PLANNING COMMISSION STAFF REPORT

DAVIS CROSSING – DESIGN PLAN

Re: Davis Crossing – Design Plan Review

SITE LAYOUT PLAN
SHEET 3 OF 5

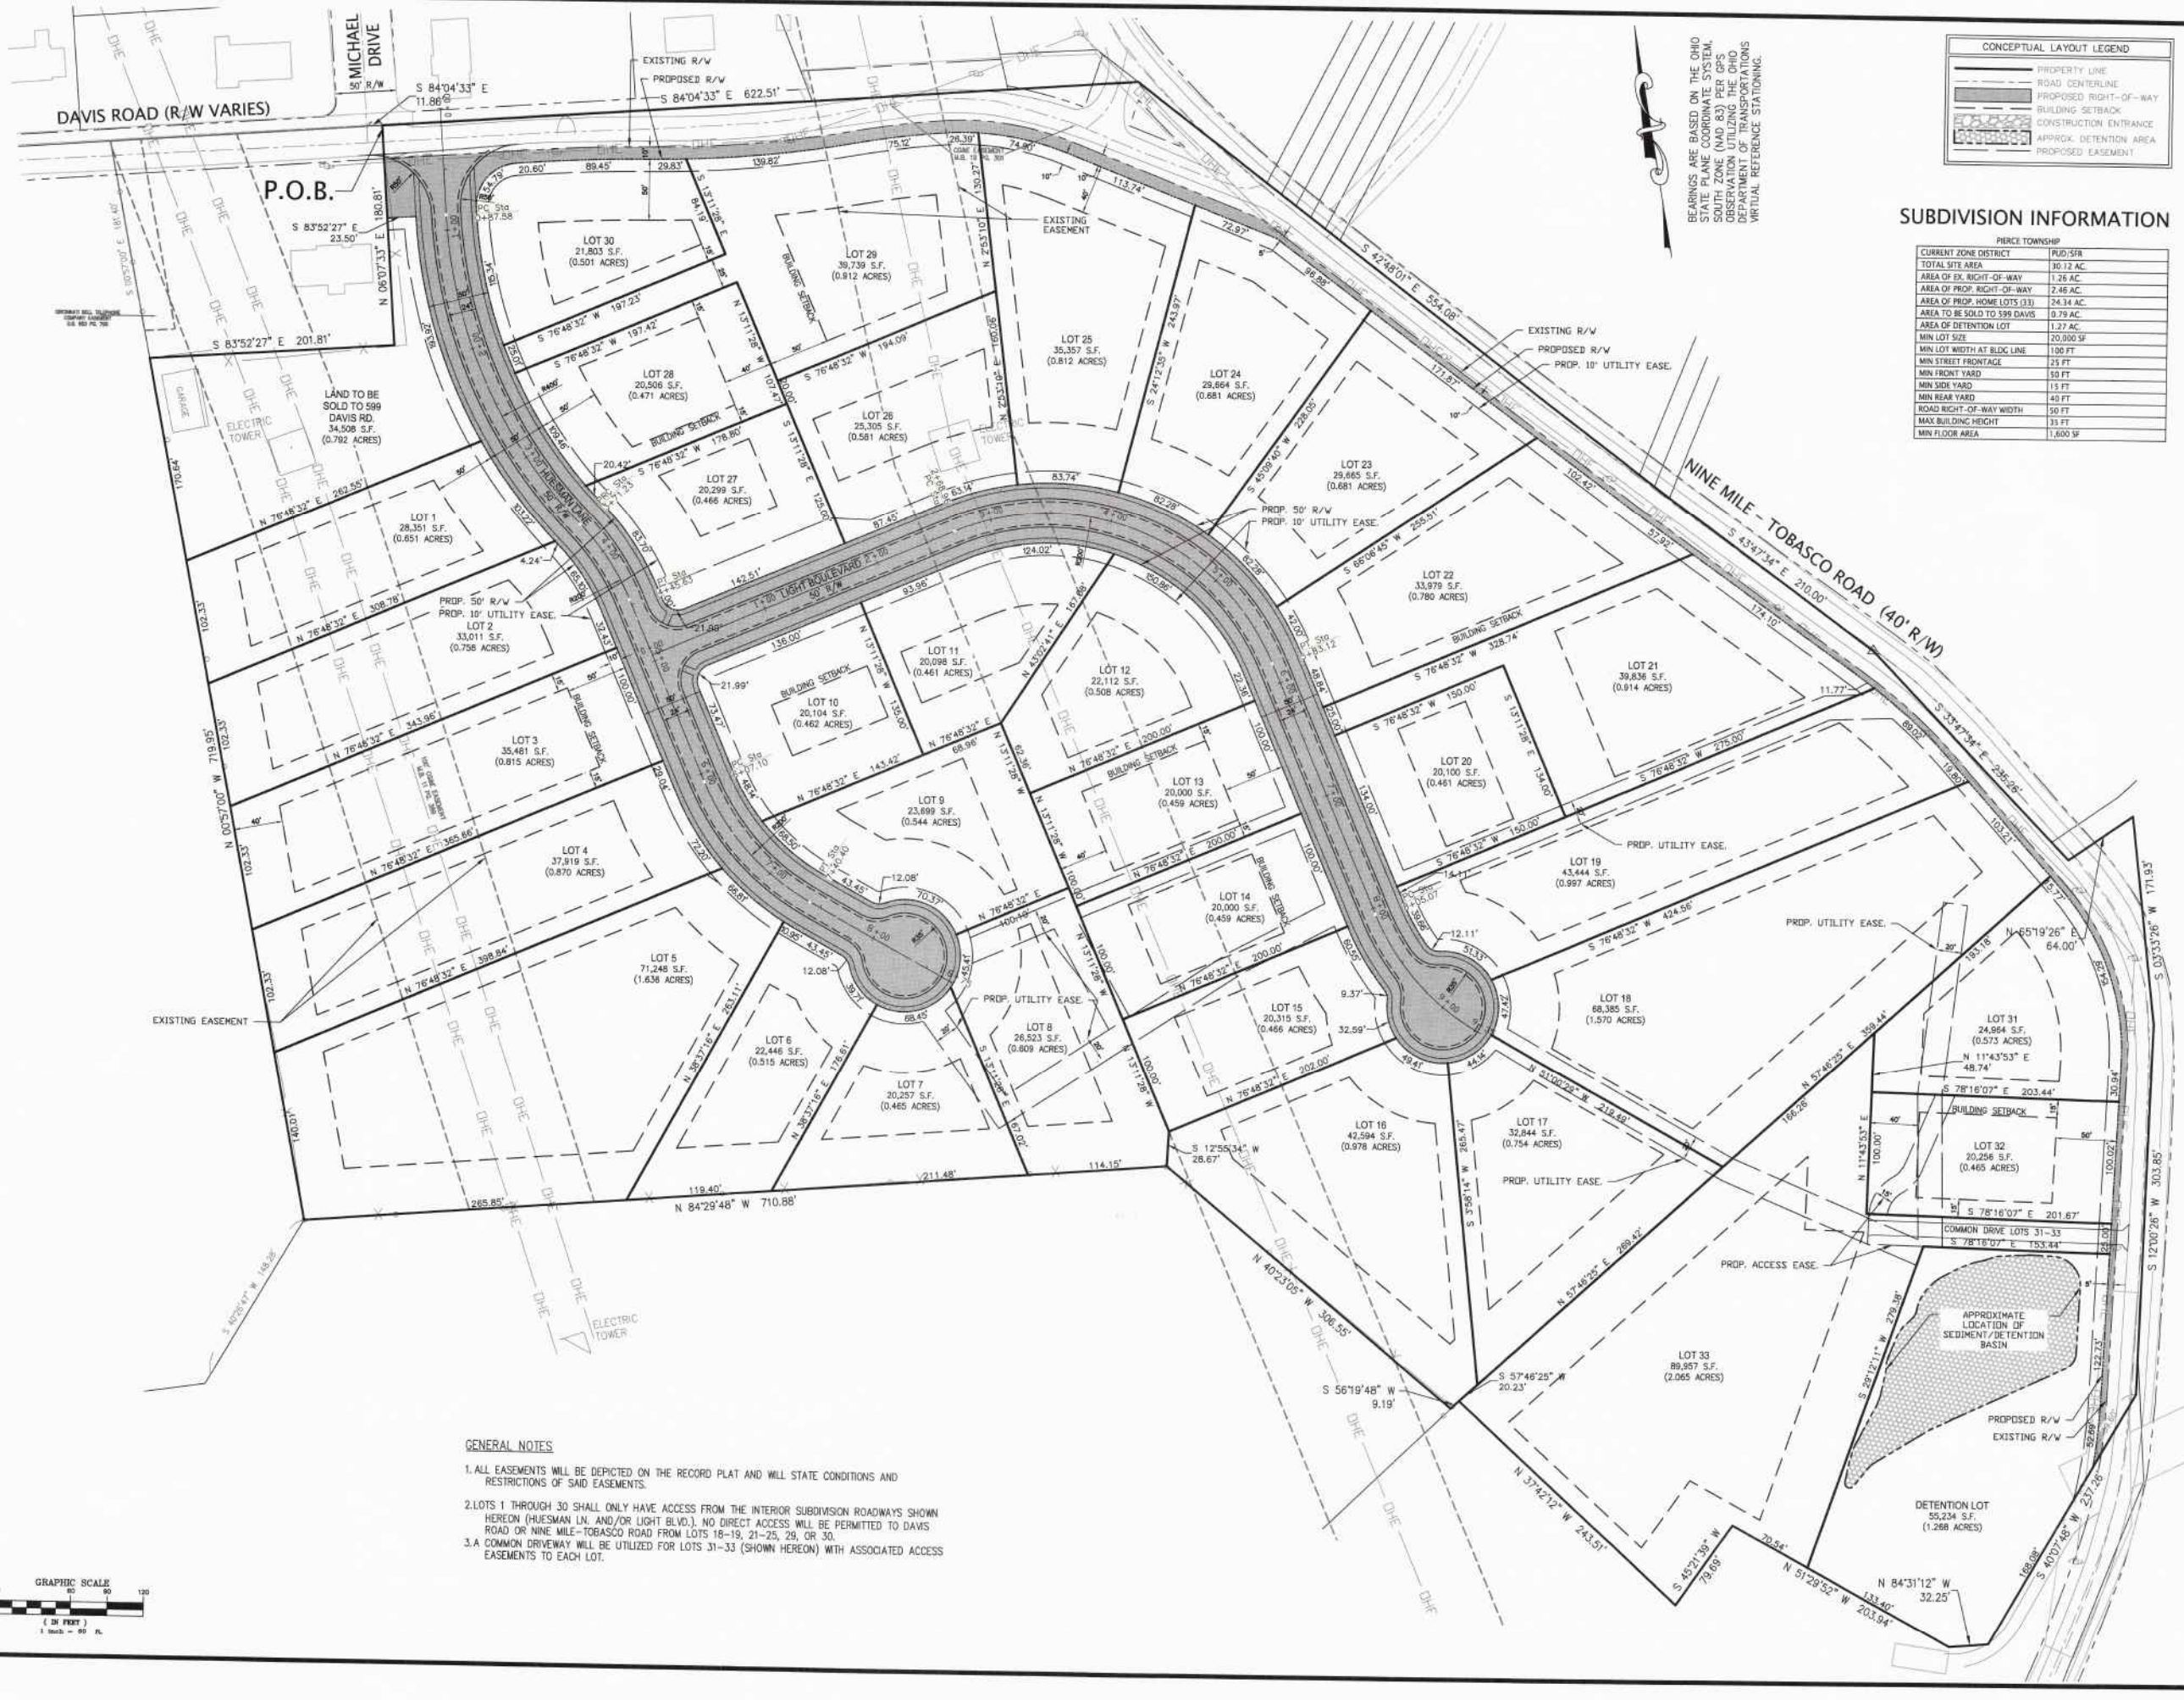
1. Confirm lot areas of Lot 29 and Lot 21 without the panhandle portion counted (Less than 50') (EM)
2. All double frontage lots must show 2 front yard setbacks, a no rear yard(s) See regulatory impacts of not having a rear yard. (EM)

- a. Lots should be notated to advise prospective buyers regarding the limitations of building(EM)
3. Front yard setbacks required off of private drives providing access to 3 or more lots – Lots 31-33(EM)

4. Revise front yards for Lots 18 and 17 (EM)
5. Confirm lot width at the building line for Lots 16-19 and 23(EM)
6. Direct access onto Ninemile is ill advised; all access should be restricted unless onto an interior roadway Visual sight lines on Nine Mile are limited (EM)

8. Multiple lots have close to or >50% coverage by overhead power easement; lots should be notated for prospective buyers regarding permissible building area(s) (EM)

1. The proposed Detention Lot needs to be assigned a Lot Number. Additionally the Detention Lot also needs to be labeled as an "Open Space' parcel.

2. The proposed Right-of-Way geometry for the Davis Road/Huesman Lane Intersection needs to be adjusted. A typical Fifty (50) Foot Right-of-way needs to be used for Huesman Lane.

1. Confirm lot areas of Lot 29 and Lot 21 without the panhandle portion counted (Less than 50') (EM)
Yes, we have confirmed the areas still meets the township lot requirements and updates figure will be included.

The county has asked us to restrict access from Nine Mile and Davis road to lots 1-30. We have added this note to this plan set and will have the restriction also recorded on the final plat/deeds. It is our interpretation that it is not frontage along a road if it can't be legally accesses from that road. If the county/township doesn't agree with that assessment, we can put an open space parcel between the back of the lots and Ninemile road.

We plan to revise and will make access to a max of only two lots off each private drive.

We confirmed lot widths at the building setback lines and they meet the requirements.

INTERSECTION SIGHT DISTANCE
SHEET 5 OF 5

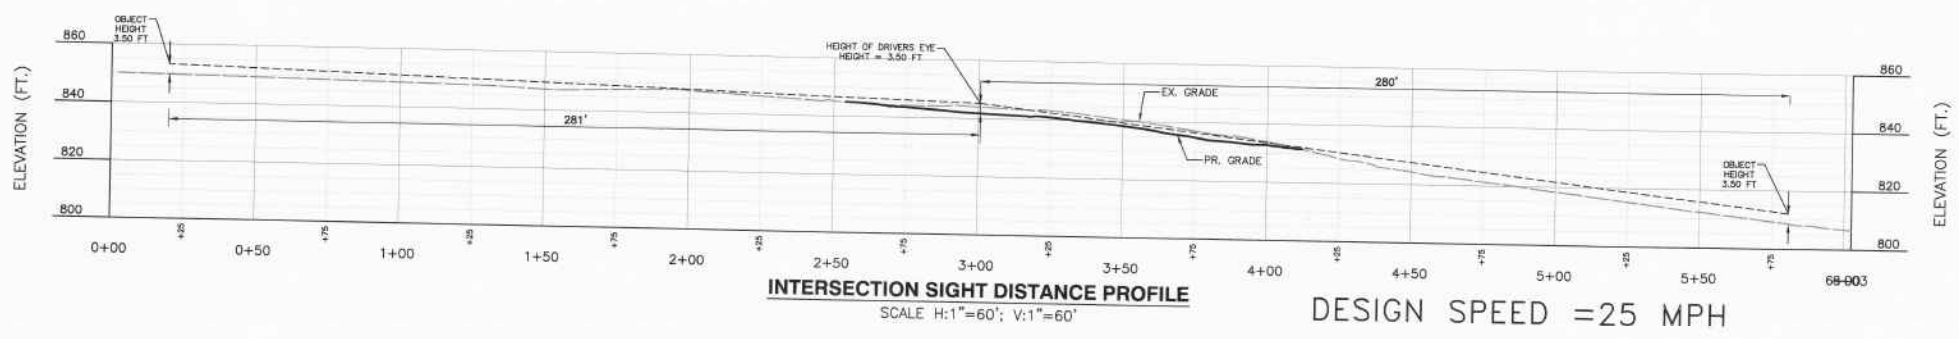
6. A Sight Distance Analysis needs to be provided for the proposed Common Drive off of Nine Mile-Tobasco Road.
7. A general reminder regarding roadway geometry; the minimum allowable street grade is 0.4%, maximum street grade is 12% (10% preferred), and the minimum centerline curve radius is 200'.

We are not sure why this is ill advised. The access from the lots onto nine mile meet all the state requirements for sight distance as submitted. See attached figure.
